PROJECT: LSTK JOB FOR ISBL WORK OF 220kV GRID POWER IMPORT AT PANIPAT REFINERY
LOA NO. RPRC182491/26286965 DTD.24.01.2020

TITLE 220/33KV SWITCHYARD-SINGLE LINE DIAGRAM

DRAWING/ DOCUMENT NO. TB-411-510-001

Comments Resolution Sheet for

SHT. No 02

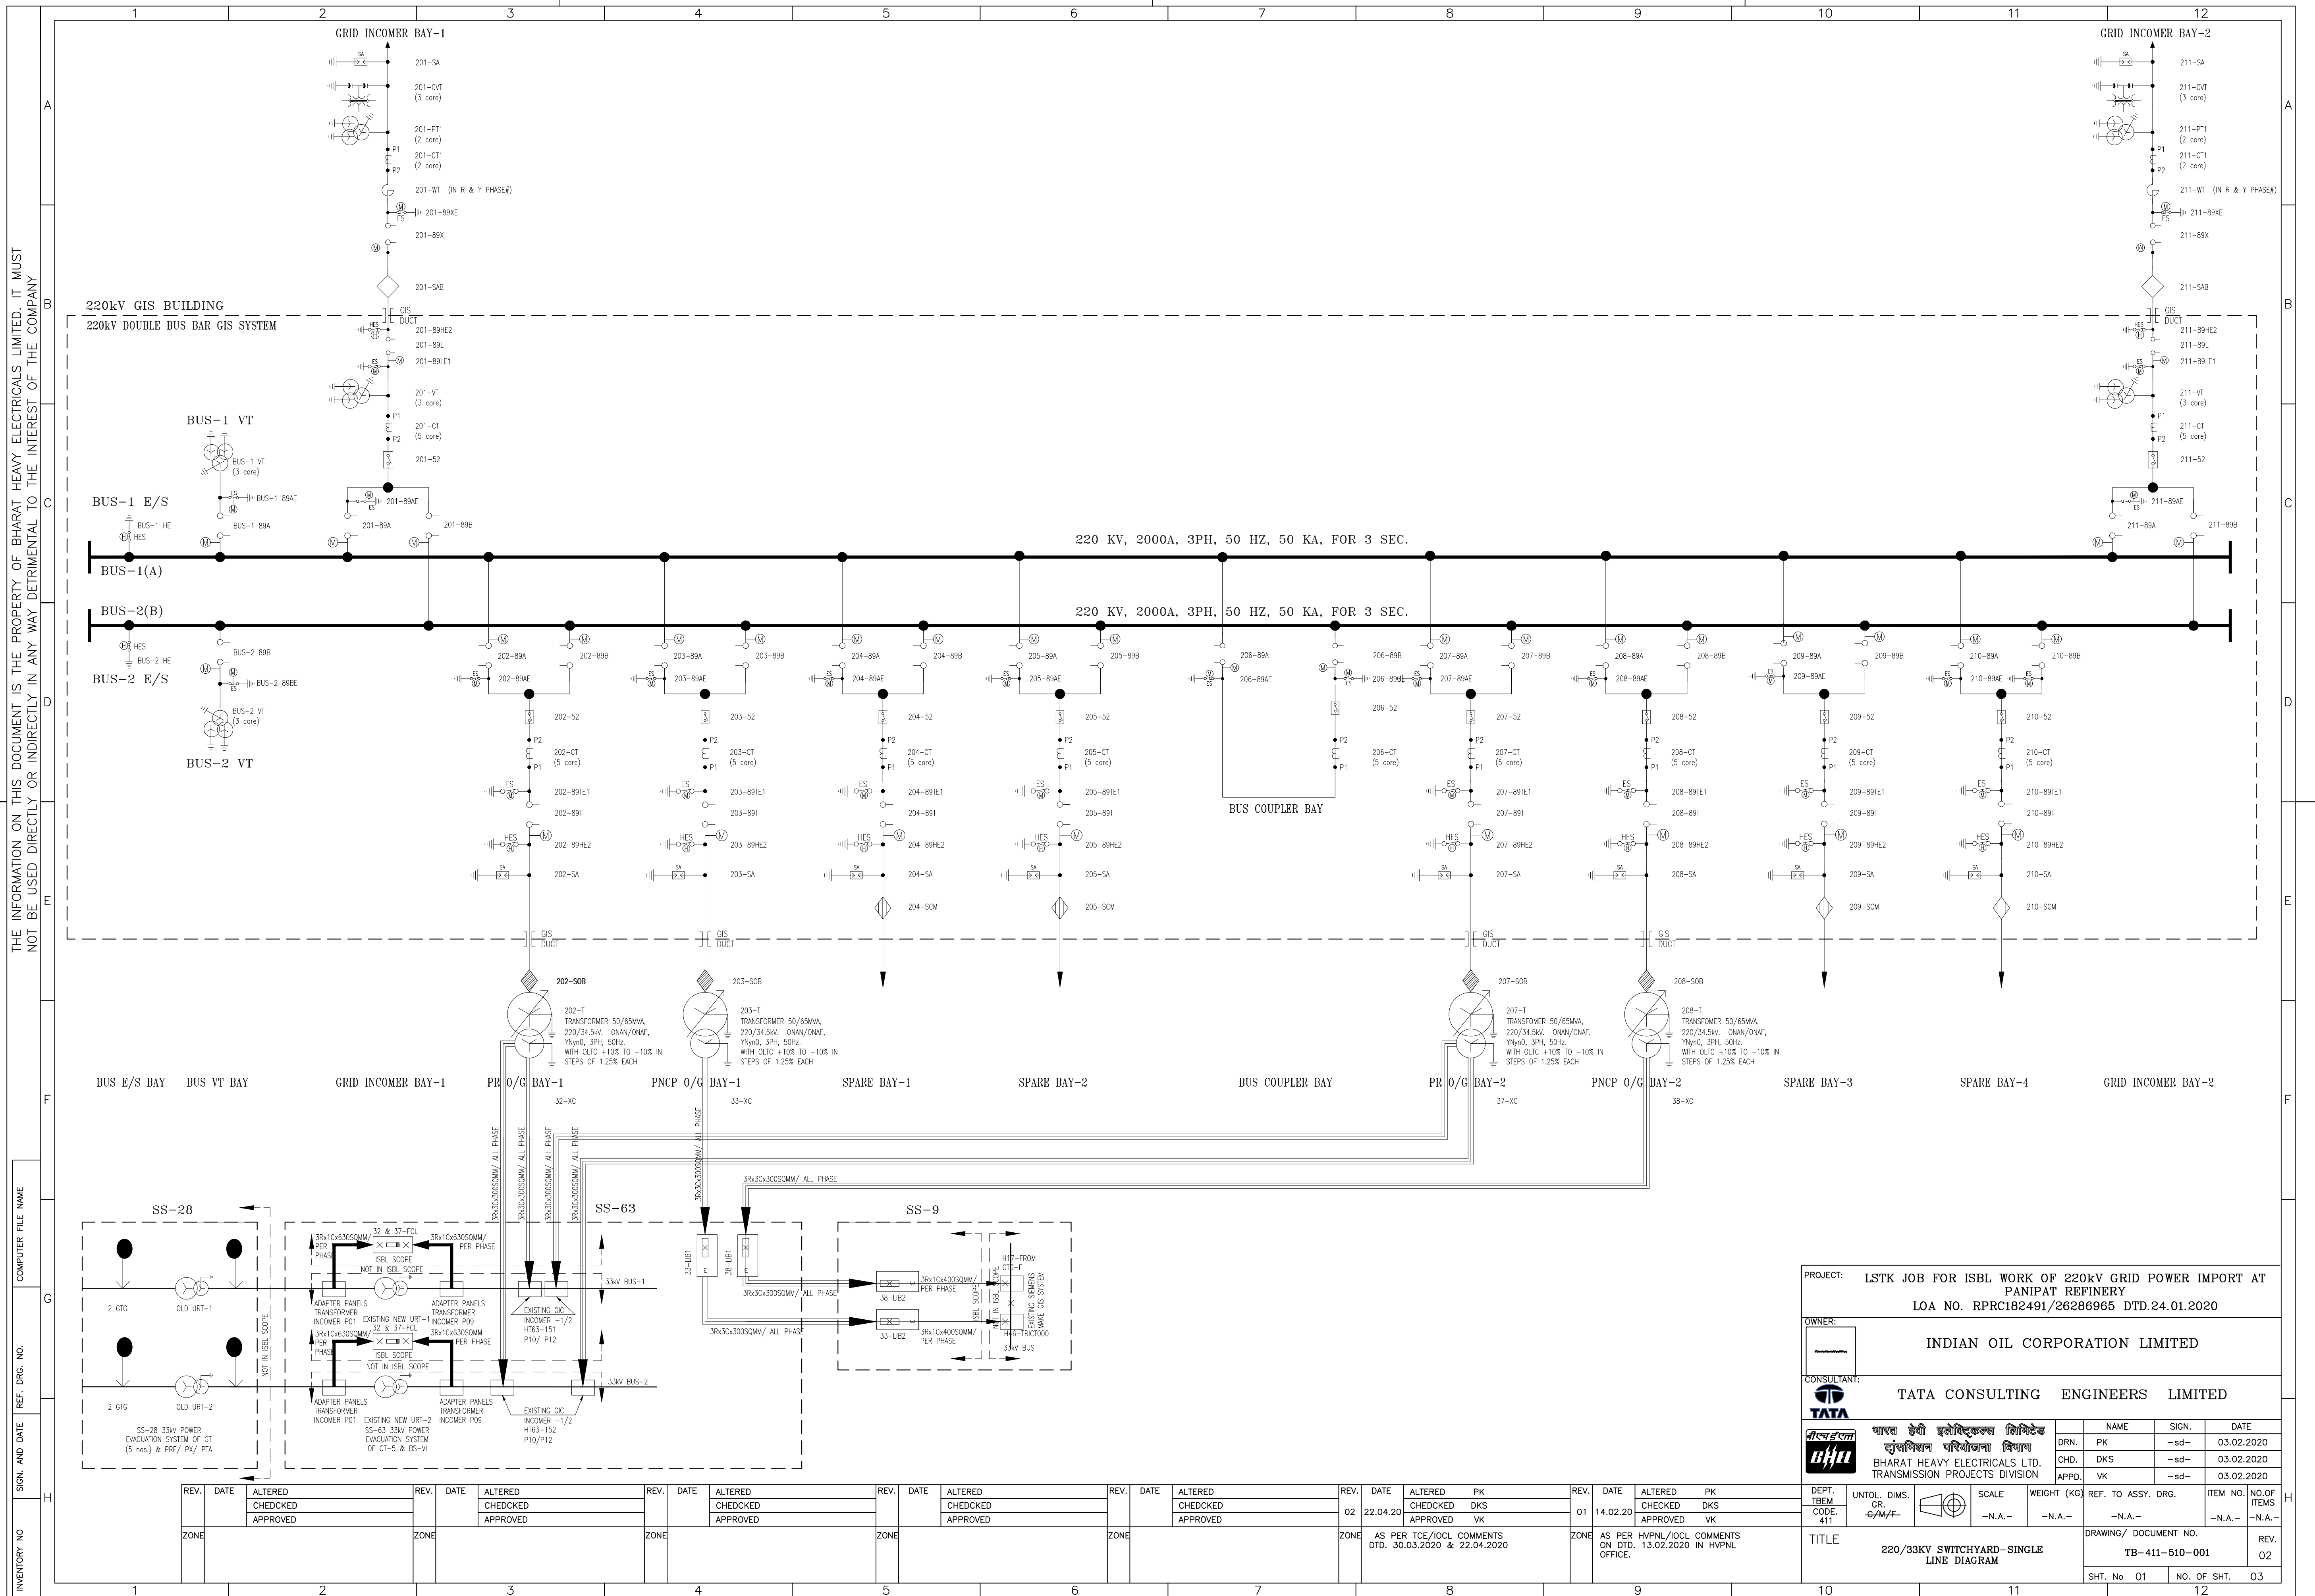
25	Sheet-2	Wave trap rating shall be 1mH	Noted and revised.
26	Sheet-2	Bay no shall be revised to 201 for sr no-4,5 & 6 in 220kV OUTDOOR EQUIPMENT	Noted and revised.

Sl. No.	Drawing Reference Details	Comment (s)/ Observation(s)	Resolution(s)
27	Sheet-2	All equipments symbol for AIS & GIS shall be different.	OEM drawing for GIS shall be submitted separately having the different symbols for GIS.
28	Sheet-2	Why 89A is shown both rows in 220kV INDOOR EQUIPMENT	Noted and revised.
29	Sheet-2	Line VT qty is missing. Qty shall be 12 Nos.	Noted and revised.
30	Sheet-2	GAS insulated bus duct-1 Lot qty shall be added	Noted and revised.
31	Sheet-2	In 33kV OUTDOOR EQUIPMENT TABLE, 220kV Bay numbers. Not applicable for 33kV. Separate SLD for 33kV shall be submitted with Bay/ Feeder numbers. Location shall be indicated with Building/ Substation Numbers	Noted and revised.
32	Sheet-2	33kV termination Not part for 33kV Equipments. Show in separate Table as indicated in drawing	Noted and revised.
33	Sheet-2	In System Parameters frequency variation shall be + 3%	This is in line with customer technical specification.

34	Sheet-2	In System Parameters short circuit rating of 33kV system is 31.5kA/1sec as per Section-1, Chapter-11, Cl. No. 5.12	Noted and revised.
35	Sheet-2	In System Parameters rated peak withstand current of 33kV system shall be 80kA	Noted and revised.

Sl. No.	Drawing Reference Details	Comment (s)/ Observation(s)	Resolution(s)
36	Sheet-2	In System Parameters BIL of 33kv system shall be 170kVp	Noted and revised.
37	Sheet-2	In System Parameters equipment design temperature shall be 50 deg C	This is in line with customer technical specification of Engineering Design Basis.
38	Sheet-2	Protection & control supply shall be +10% & -20%. 1. Trip Coil Operating Range: 220VDC -70% +110% 2. Close Coil Operating Range: 220VDC -80% +110%	This is in line with customer technical specification of Engineering Design Basis. Noted and revised.
39	Sheet-2	Transformer Bushing CT details to be provided	These details shall be updated in line with OEM drawings.
40	Sheet-2	For tariff metering "Use of only single ratio metering CT will be allowed. Multi core CT are not to be used in any case" as per Appendix-I B, HVPNL guide lines for installation of metering equipment, sr no-ix.	This requirement is not pertaining to this drawing and shall be complied in Protection Single Line Diagram (TB-411-510-002) and hence, CT VT Parameters are deleted from this drawing/ document.

41	Sheet-2	CT sizing calculation to be submitted.	This requirement shall be submitted in separate design document.
42	Sheet-2	Kindly make CT/VT parameters legible.	Noted and revised.
43	Sheet-2	Kindly mentioned Reference drawing details.	Noted and complied.
44	Sheet-2	Orientation/Section of the CT cores shall be in line as per IOCL comments dtd. 27.02.2020. Same to be followed in Protection SLD.	Noted.

TITLE: 220/33KV SWITCHYARD- LAYOUT PLAN & SECTION

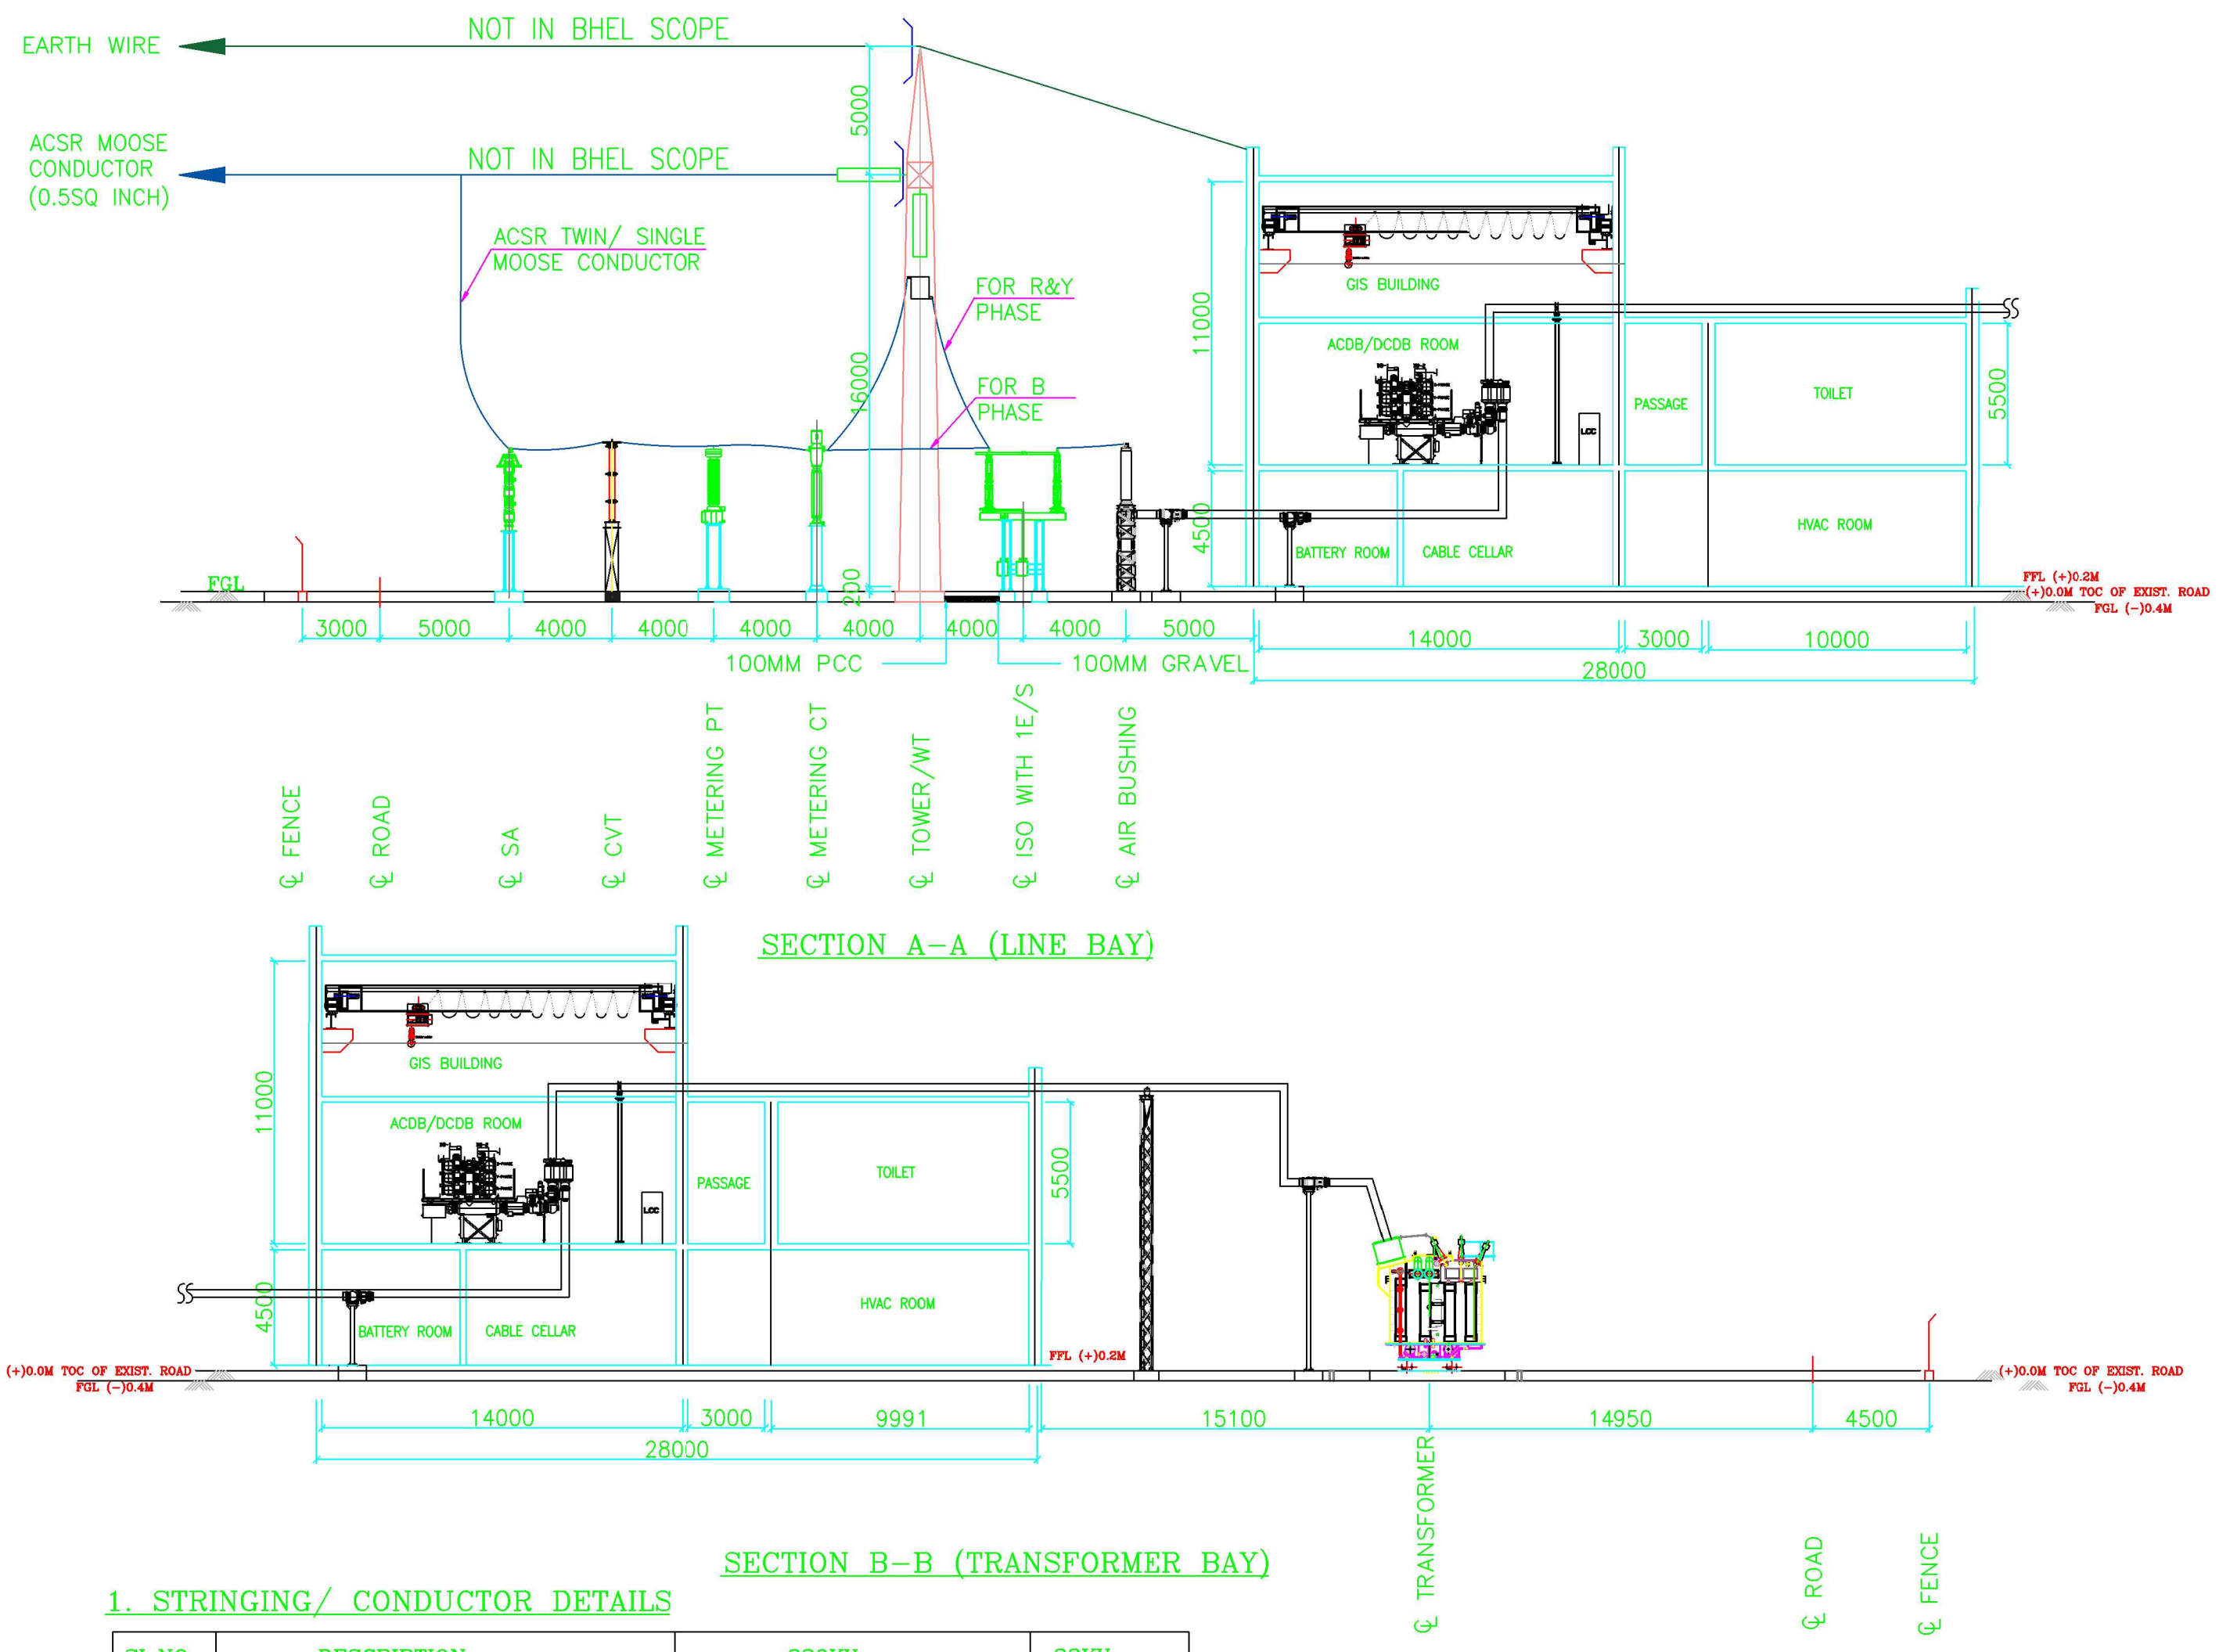
Sl. No.	Drawing Reference Details	Comment (s)/ Observation(s)	Resolution(s)
A.	CONSULTANT (dtd. 20.03.2020)		
1	General	Comments on GIS cum Control Building provided separately. Drg to be updated in line with same.	Noted. As per project requirements, concurrent approvals of other related drawings are also going on and hence such associated details shall be updated in final submisison after finalization of details from OEMs.
2	General	In upper right most corner of drawing Indicate the Overall Plot Plan & show in hatch present scope area in Over all Plot. Mark True North & Plant North.	Noted and complied.
3	General	Scale of fence shown in plan to be reduced	Noted and complied.
4	BOQ	Tower qty & description to be corrected mentioning -16.2Mtr Tower with 5Mtr peak suitable for 2 beam mounting arrangement- 1 No -16.2Mtr Tower with 5Mtr peak suitable for 1 beam mounting arrangement- 2 Nos	Standarized tower (16m) having the provision of both side beam/ gantry (18m) arrangement is made for all the three towers.

5	Section A-A	ACSR Moose Conductor single or twin to be mentioned	Provision for twin/ single ACSR moose conductor is taken, however, this is to be confirmed by customer based on the line arrangement.
6	Section A-A	Outdoor equipment interconnection to be shown either tube or conductor	Provision for twin/ single ACSR moose conductor is for outdoor equipment connection is made.

Sl. No.	Drawing Reference Details	Comment (s)/ Observation(s)	Resolution(s)
7	Section A-A	Distance between equipments can be reduced if required	This is finalized and frozen in line with Customer/ HVPNL guidelines.
8	Wave trap	As per IOCL specification, Annex-S-3/C-4/3, cl no-1.3, "line trap shall be suitable for outdoor suspension mounting". Whereas in BOM, Annexure S-2/C-1/2, "bus post mounted type Wave Trap" is mentioned. Mounting arrangement of Wave trap to be confirmed with HVPNL & IOCL.	As per customer/ HVPNL guidelines, line trap shall be outdoor suspension type.
9	Plan	Centre line of fence to centre line of road distance (north side) shall be 6Mtrs instead of 4.5Mtrs.	This is finalized and frozen in line with Customer requirement and consent.
10	Plan & Section B-B	Centre line of Transformer & edge of control room build is mentioned 12.1Mtrs in section whereas in plan it is mentioned as 15.1Mtrs. Please check & update.	Noted and revised.

11	Plan	Cable Trench is shown for Transformer Marshalling Box. Pipe sleeves shall be provided for TR MB.	Noted and any modification shall be done in line with OEM drawings.
12	Plan	Cable Trench shall be shifted to 33kV Cable Box of Transformer. Kindly provide details of 33kV Cable termination considering rails provided in plan layout.	Noted and any modification shall be done in line with OEM drawings.

Sl. No.	Drawing Reference Details	Comment (s)/ Observation(s)	Resolution(s)
13	Plan	Oil Collection Pit can be one, common for all Transformers. Relocate the pit at suitable location.	These details are tentative and shall be revised, if required in line with OEM drawings/ design documents.
14	Plan	Show section B-B as indicated in drawing	Noted. Section B-B is indicated in drawing.
15	Plan	Numbering shall be given to Transformer. (eg- TR-1, TR-2 etc.)	Noted and any modification shall be done in line with OEM drawings.
16	Plan	Centre line of fence to centre line of road distance (south side) shall be revised.	Noted and revised.
17	Plan	Un-climbable fencing around metering CT/PT area is to be provided which will be sealed by DISCOM/HVPSNL as per Appendix-I B, HVPSNL guide lines for installation of metering equipment, sr no-viii.	This drawing is pending for approval with HVPSNL. In case of any such requirement, same shall be taken care

18	Legend	Use different line properties, there is no difference visible now.	Noted and Revised.
19	Notes	No lighting shall be provided on Tower or Gantries.	Please note that provision for fixing the lighting fixtures on the Tower is considered. This is standard practice with central/ state utilities, however this option shall be exercised on no choice basis.

Sl. No.	Drawing Reference Details	Comment (s)/ Observation(s)	Resolution(s)
20	General	For tariff metering "Use of only single ratio metering CT will be allowed. Multi core CT are not to be used in any case" as per Appendix-I B, HVPNL guide lines for installation of metering equipment, sr no-ix.	This shall be in line with approved Protection Single Line Diagram.
21	Section A-A	Placing Metering CT & PT between CVT & Wave Trap for communication need to be confirmed with PLCC Vendor whether it will function correctly or not.	This is in line with customer/ HVPNL guidelines, however, any specific issue, if comes shall be taken up with customer/ HVPNL, if required.
22	BOQ	Remove ratio of CVT from description	Noted and revised.
23	BOQ	Wave trap rating shall be 1mH instead of 0.5mH. Shall be checked and complied.	This shall require customer/ HVPNL confirmation.
24	Wave trap	Kindly confirm with HVPNL regarding mounting of Wave trap on which phases?	This is finalized and frozen in line with Customer requirement and consent.

25	Plan/Section	Comments regarding BUS duct routing for Transformer bay is provided in GIS cum Control Building drawing. Kindly check if GIB length can be optimised. If GIB is taken above the roof then adequate clearance from roof floor level to be maintained for roof maintenance.	Please note that these details are tentative and indicated and shall be revised based on OEM drawings, which shall be submitted separately and such requirements shall be taken care during that.

Sl. No.	Drawing Reference Details	Comment (s)/ Observation(s)	Resolution(s)
26	Section B-B	Conductor, earth wire & Tension insulator hardware from Takeoff tower to transmission line tower will be not in BHEL scope. Note to be mentioned in drawing after confirmation.	Noted and revised.
27	Stringing / conductor details	Transmission line conductor to be confirm by HVPNL. Do not specify in drawing. Generally 220kV Line conductor is Zebra, same to be confirmed with HVPNL/IOCL	These details still pending with customer/ HVPNL.
28	System parameters	33kV system paramter revised as per marked in drawing.	Noted and revised.
29	BOQ	Wave trap if pedestal mounting, then qty of BPI to be added in BOQ	Noted.
30	Plan	Indicate the Finished Ground Level & Coordinates of Substation area in all corners.	These details are not provided at customer end and hence these details shall be acoomodated during site work and shall be mentioned in as built drawing.

31	Plan	Show the reference points from Existing Building/ Structure and Roads.	These details are not provided at customer end and hence these details shall be acoomodated during site work and shall be mentioned in as built drawing.
32	Plan	Fence dimensions shall be marked upto Existing Road & Existing Buildings in all directions.	These details are not provided at customer end and hence these details shall be acoomodated during site work and shall be mentioned in as built drawing.

Sl. No.	Drawing Reference Details	Comment (s)/ Observation(s)	Resolution(s)
33	Plan	Transformer dimensions indicated (16x10m) seems to be on Higher side. 12x10m may be sufficient for the 65MVA Transformer (Please check & confirm with Transformer OEM) and rearrange the layout suitably.	Noted. These details shall be updated in line with OEM drawings.
34	Plan	GIS cum Control building dimensions are not matching between Plan & Sections. Update as applicable.	Noted and revised.
35	Plan	Cable Trench may be removed from overall Plot plan. Same can be indicated separate drawings.	These details are tentative details for understanding the complete requirements.
36	Plan	Tariff Metering room area details not provided in "Appendix-I B, HVPNL guide lines for installation of metering equipments" Tariff metering room size shall be confirmed by HVPNL & approval of same to be taken.	This is finalized and frozen in line with Customer requirement and consent.

37	Section A-A	Kindly check routing of line bays bus duct can be taken from wall instead of cutout in GIS room ground floor slab.	These details are derived from customer requirement mentioned in line with specification, however it shall be updated in line with OEM drawings.
38	Notes	Text properties shall be same for all notes (sr no-14&15)	Noted and revised.

Sl. No.	Drawing Reference Details	Comment (s)/ Observation(s)	Resolution(s)
39	Plan	Periphery road size to be increase for transportation of GIS & other equipment. 4mtr road will not be sufficient. As per plan layout provided in 7th corrigendum, road size shown as 5mtrs. Kindly check.	Noted and revised.
40	System parameters	System fault level for 220kV system is 50kA/3sec as per 7th corrigendum, Annex-S-3/C-1/3	Noted and revised.
41	Reference	Drawing reference nos shall be provided.	This is in line with customer/ HVPNL technical specification.
42	Section A-A	Ground clearance distance shall be mentioned section drawing.	This shall be in line standard clearances mentioned in table.
43	Plan	If Building is less than 15mtrs from Transformer outer Body Control Building wall be of Fire Wall grade	Requirement shall be taken care in civil design document/ drawings.
B	CUSTOMER (dtd. 30.03.2020)		
1	No comments
